RS-01-263

Dresden Nuclear Power Station, Units 2 and 3
Facility Operating License Nos. DPR-19 and DPR-25
NRC Docket Nos. 50-237 and 50-249

Quad Cities Nuclear Power Station, Units 1 and 2
Facility Operating License Nos. DPR-29 and DPR-30
NRC Docket Nos. 50-254 and 50-265

Subject: Additional Electrical Information Supporting the License Amendment
Request to Permit Uprated Power Operation at Dresden Nuclear Power
Station and Quad Cities Nuclear Power Station

Sample Coordination Plot for Relay Settings

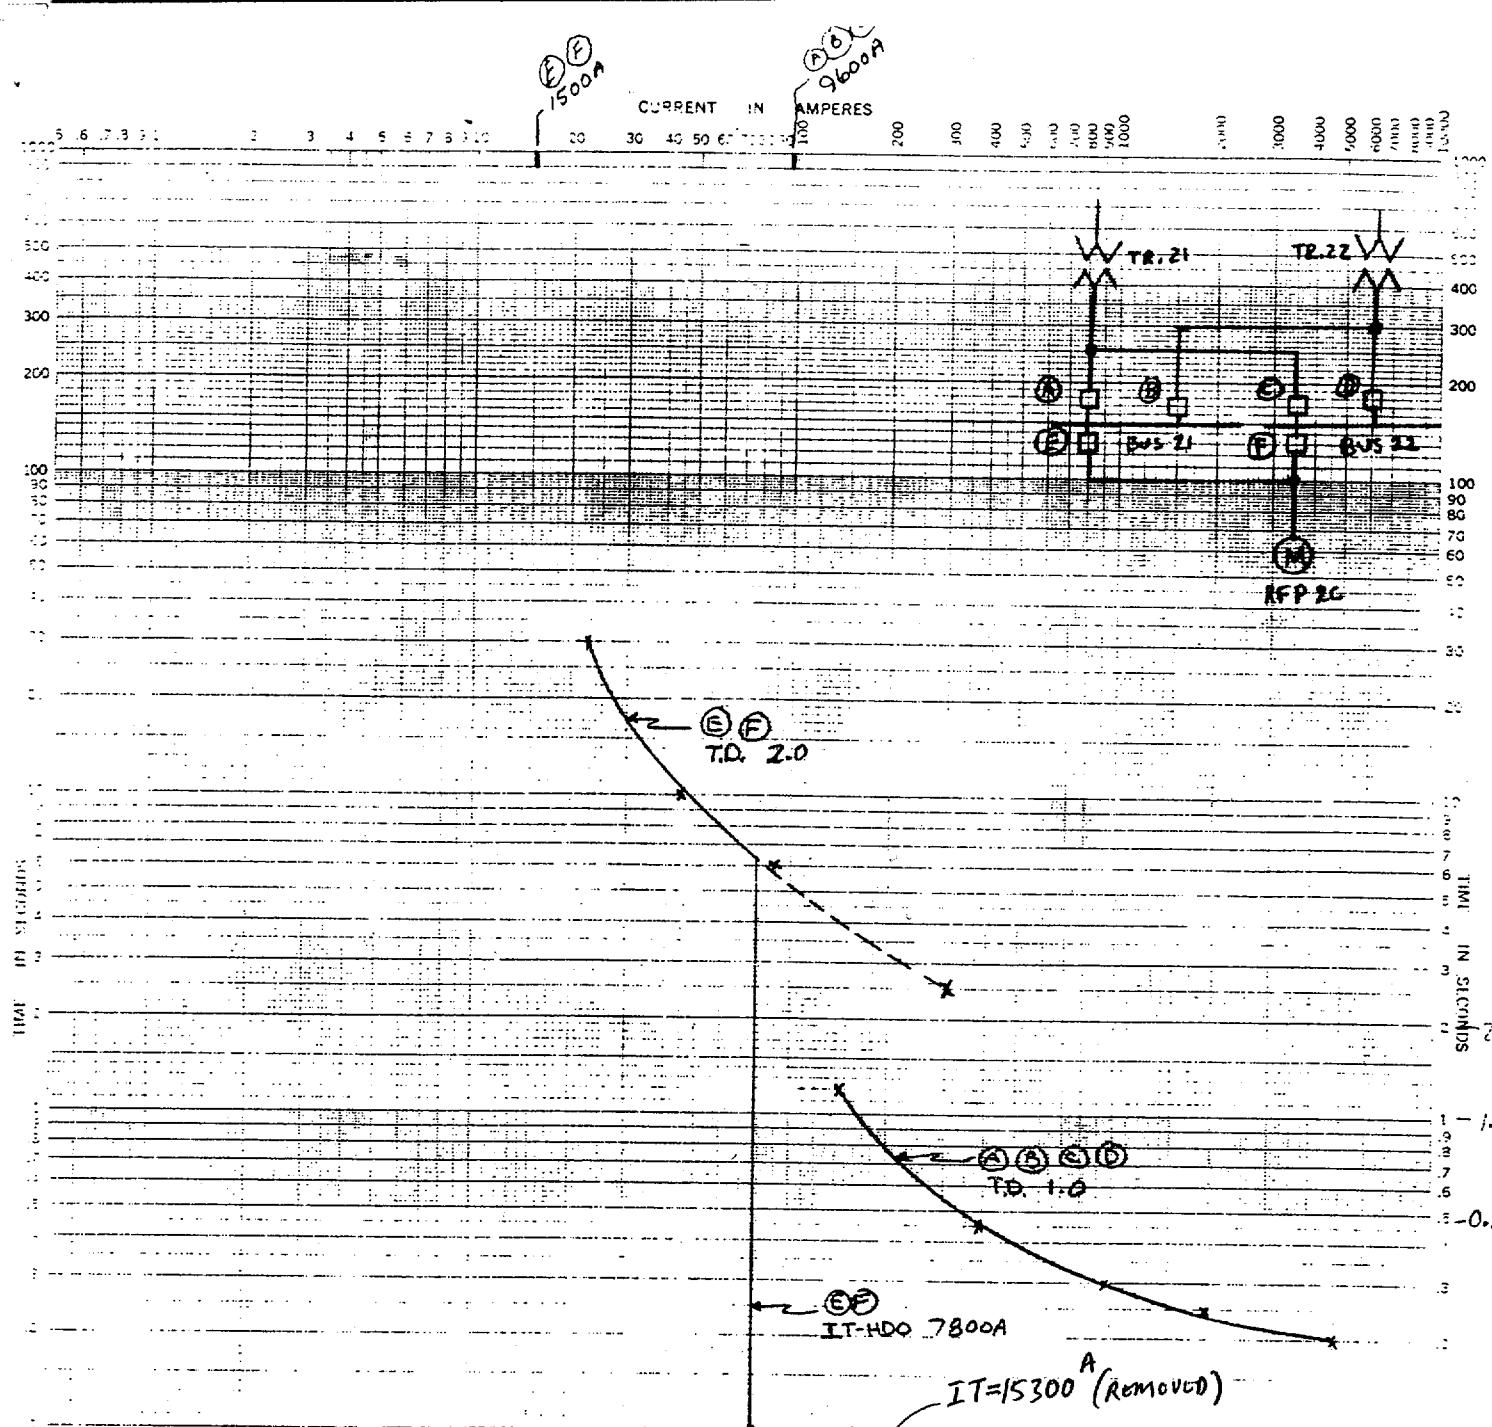
Provide details concerning the impact of the extended power uprate (EPU) on the scenario in which either the unit auxiliary transformer (UAT) or the reserve auxiliary transformer (RAT) become unavailable, causing the running loads to be transferred to the remaining available transformer. a.) Describe the evaluations that determined the acceptability of the increased running loads and any potential short circuit conditions while in this configuration. Provide manufacturer data for the protective relay and a sample coordination plot for the relay setting to support this determination. b.) Describe the operator actions for responding to this scenario and how they change for EPU.

The protective relay settings to protect against a short circuit for this scenario were discussed in References 1 and 2. These relays are GE type IAC 66M time overcurrent relays that contain both an instantaneous overcurrent setting and a high dropout setting with a time delay. Manufacturer information for this relay is provided in Attachment B. As described in References 1 and 2, the instantaneous overcurrent relay for the load breakers for buses 21, 22, 31, and 32 for DNPS and buses 11, 12, 21, and 22 for QCNPS will be disconnected, leaving the high dropout feature, which will actuate after a six cycle (i.e., 0.1 second) time delay. Based on ANSI/IEEE C57.12, the UAT and RAT can provide the short circuit current for two seconds without damage. Based on the protection scheme coordination curves, the capability of the 4 kV bus duct to withstand the short circuit current is not affected by the six cycle time delay. Thus, the overcurrent relays still provide adequate protection. The remaining portions of the protective relaying were not changed for EPU. The coordination between the main breaker to the switchgear, the motor feeds, the bus duct capability, and the transformer capability curve is maintained. A sample coordination plot showing the adequacy of the relay settings is provided in Attachment C.
